ZERO DOWNTIME*

VOLUME 2

NUMBER 5

MAY

PEPPER II AUDIO MODIFICATION

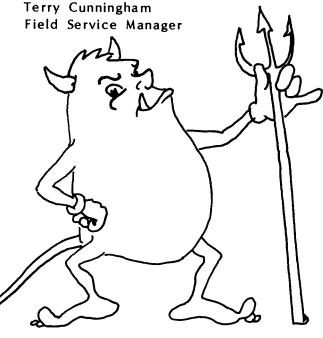
On the earliest model of PEPPER II it may necessarv to make this audio modification. At position E-1 on the audio board there may be a resistor modification wire connecting the resistor in the C-6 slot at position E-1 to the potentiometer R9 at position B/C-1. Remove the resistor and the mod wire. That's it.

If the resistor is left connected in the audio circuit the "bumpa-bumpa-bumpa" sound will not be loud enough to hear over the music. Removal of the resistor makes the "bumpa-bumpa- bumpa" volume more equal to that of the music.
